Index 102-615 Multilane Roadway, Intersection Work

COMMENTARY

COMMENTS AND RESPONSES

LAST REVISION 11/01/21	REVISION	DESCRIPTION:	 FY 2022-23 STANDARD PLANS	MULTILANE ROADWAY, INTERSECTION WORK	INDEX 102-615	SHEET 1 of 5
---------------------------	----------	--------------	---	--------------------------------------	------------------	-----------------

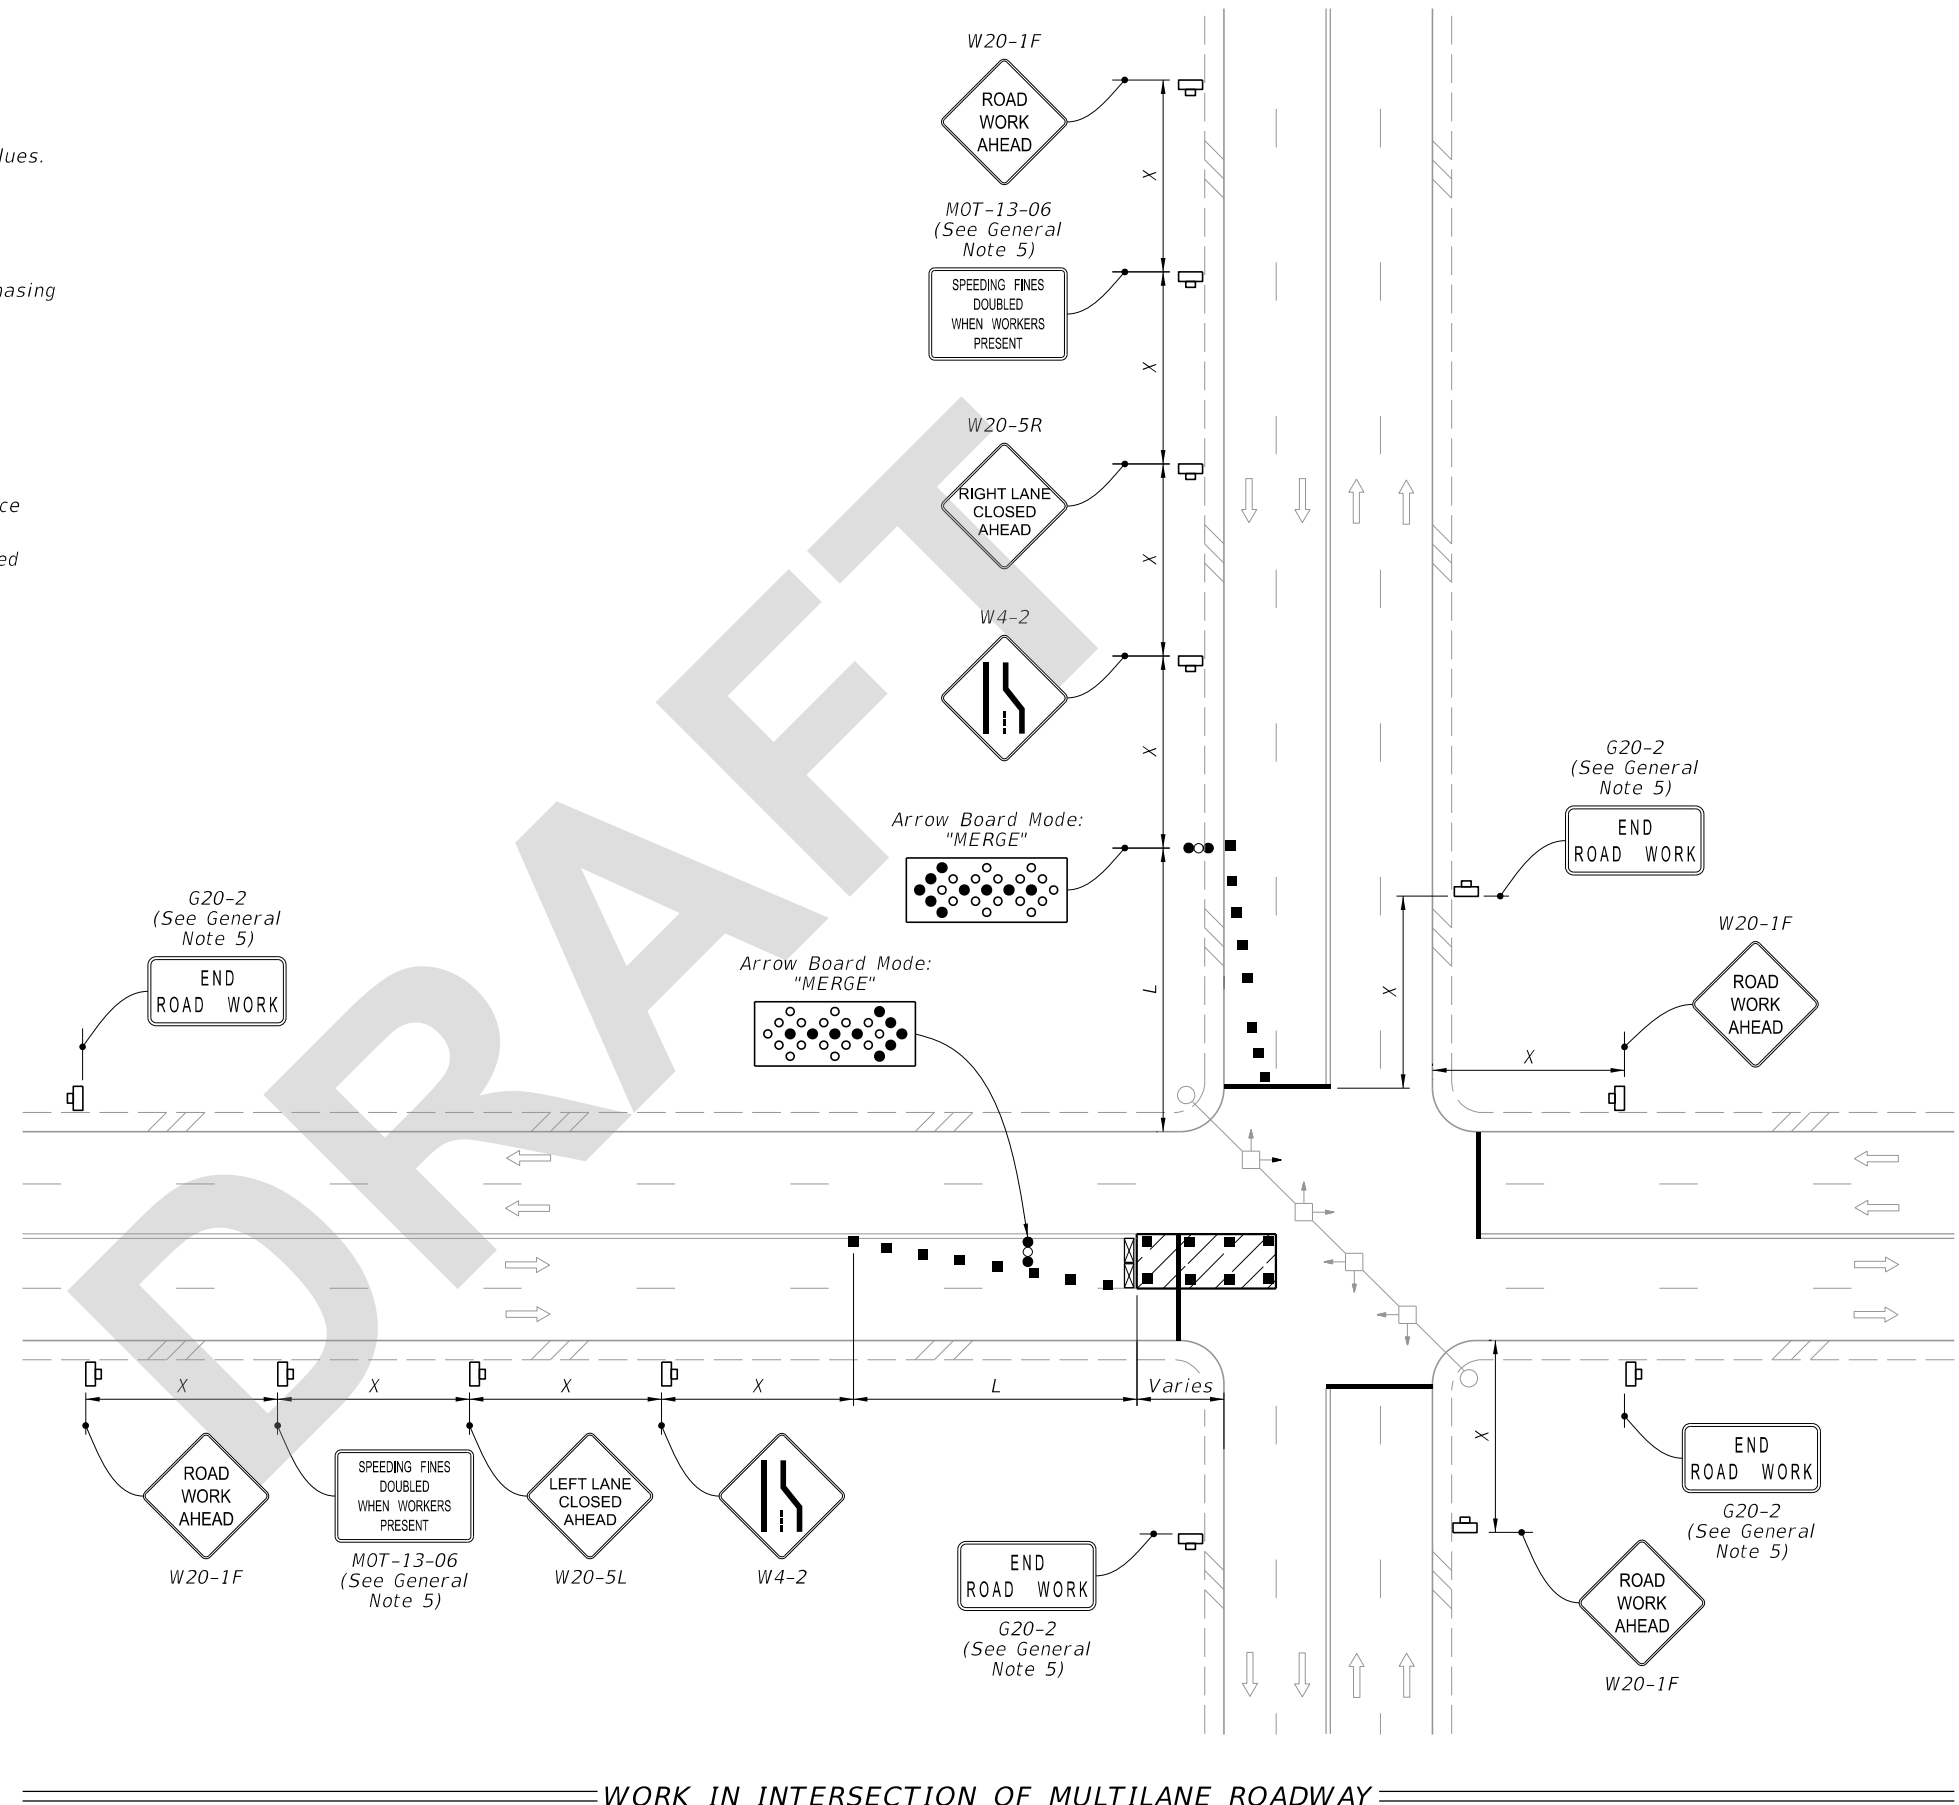
Sheet 1: Changed Note 5 - "work zone" to "work operation";
Deleted Note 8.
Added Arrow Board Mode: "Merge" to the detail.

1. Draft page 1/5: Please verify the merge arrow shown on Arrow Board for the closure of the outside lane. The Merge arrow is now shown directed to the shoulder; correction may be necessary. Screen shot-

RESPONSE: All of the Signs and Arrow Boards throughout the 102 Series are orientated in the details to the perspective of a user standing in the field looking in the direction of traffic (i.e., a left merge is shown with left pointing arrow). If the arrow boards were to be shown oriented with the page, then all of the signs for opposing traffic directions would need to be shown upside down, which is not preferred.

No Change Made

LAST REVISION 11/01/21	REVISION	DESCRIPTION:		FY 2022-23 STANDARD PLANS	MULTILANE ROADWAY, INTERSECTION WORK	INDEX 102-615	SHEET 4 of 5
---------------------------	----------	--------------	--	------------------------------	--------------------------------------	------------------	-----------------

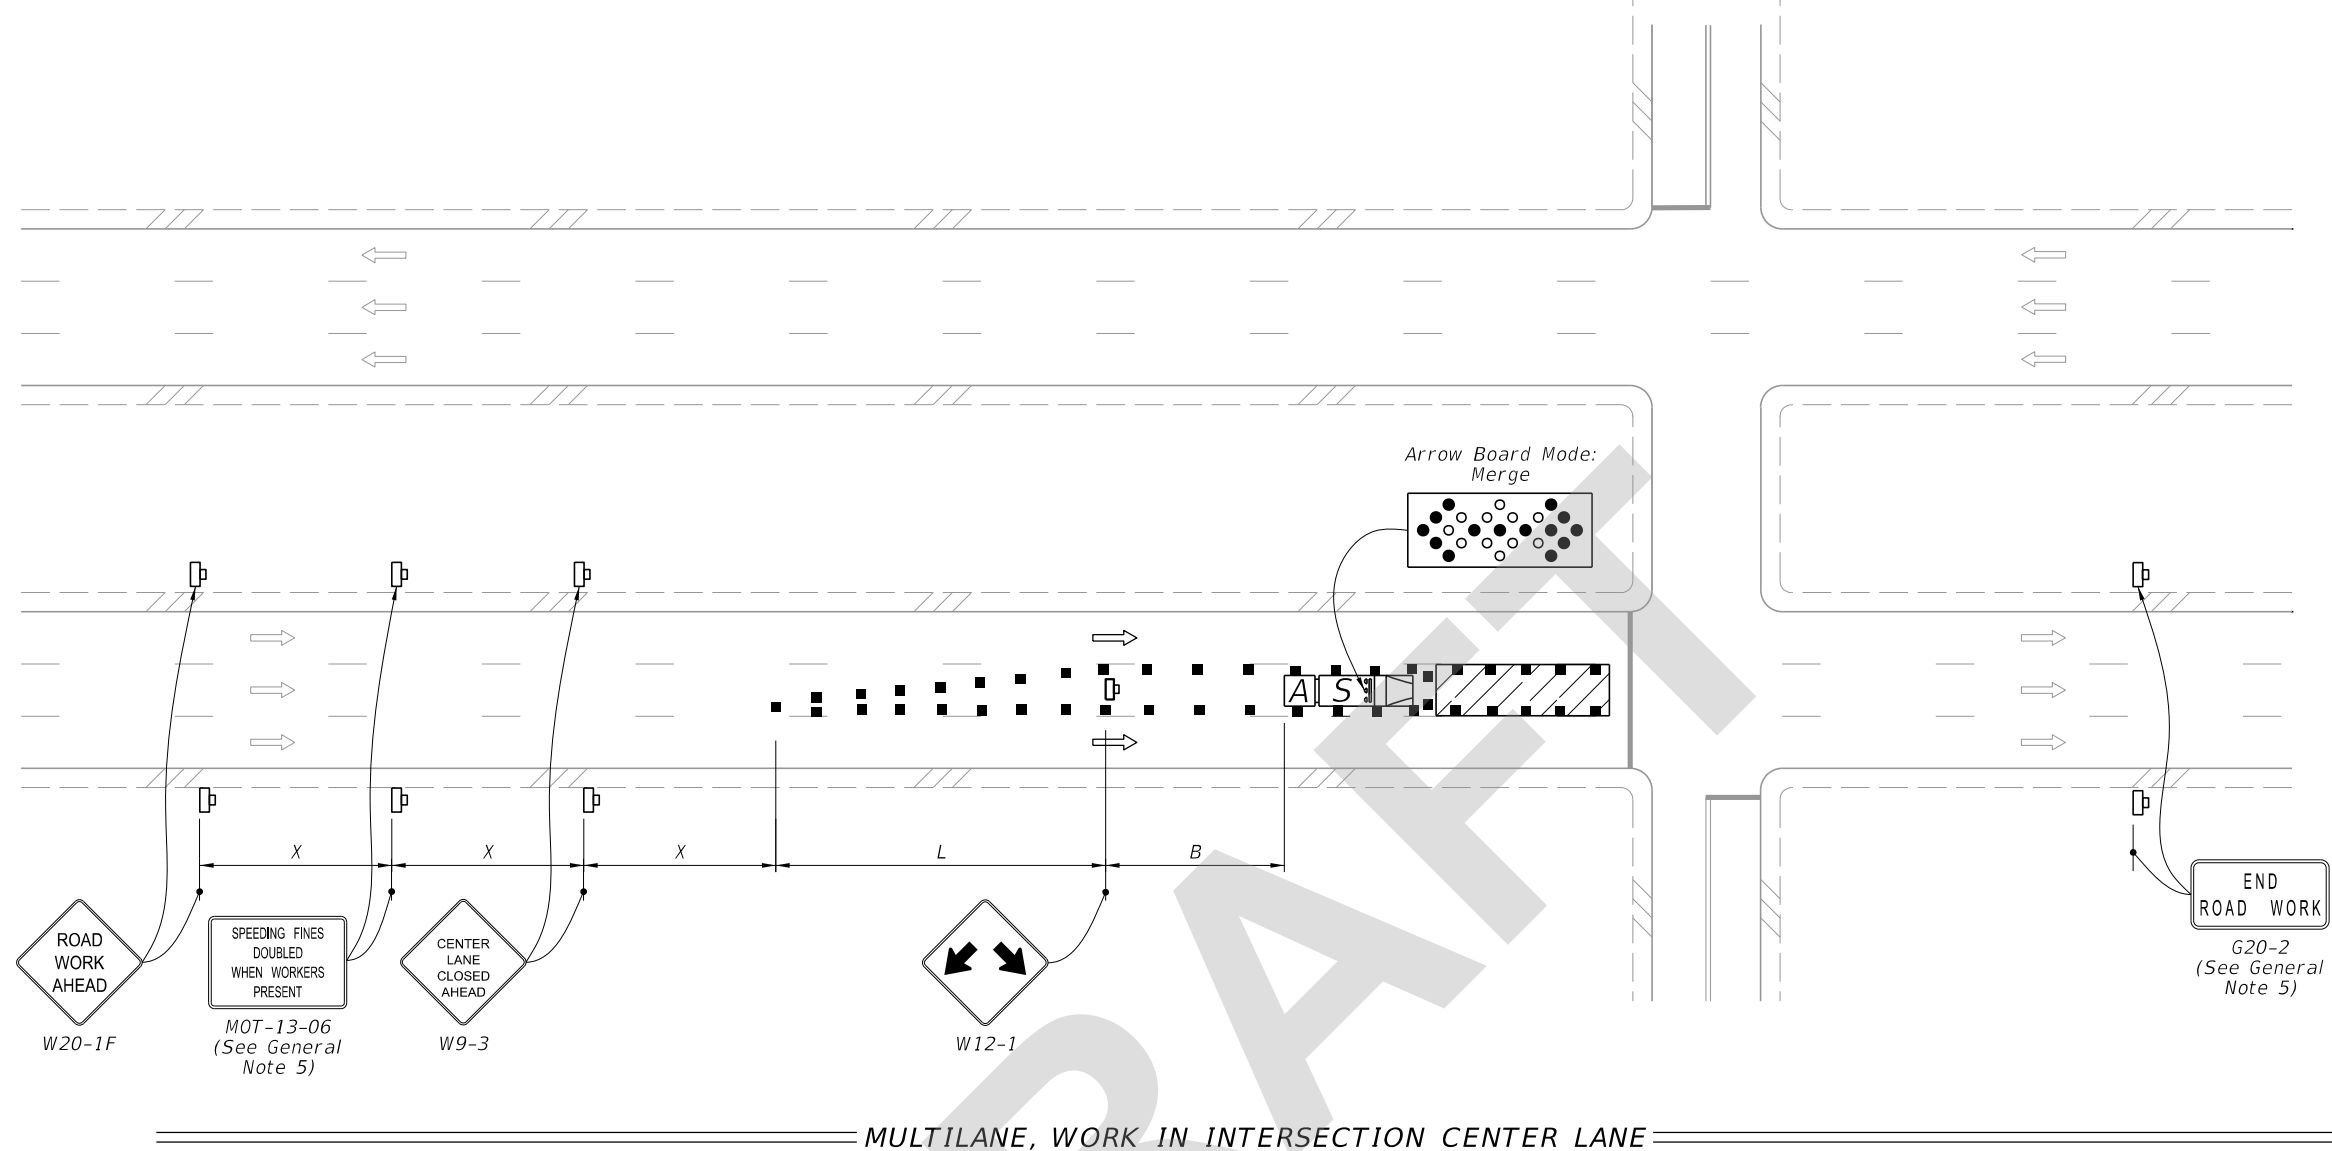
Sheet 4: Moved buffer zone and the associated dimension "B" before the Truck Mounted
Attenuator in the work zone.

2. Draft page 4/5:- Consider to place an Advance warning Arrow Board (Move/ Merge Rt or Lt) placed ahead of Truck mounted Attenuator(TMA) when work is performed in the center lane.

RESPONSE: Agree that an Arrow Board should be in use; however, we believe that boards mounted on a Shadow Vehicle are appropriate.

Change Made: Add Arrow Board "Mode" call-out to the Shadow Vehicle.
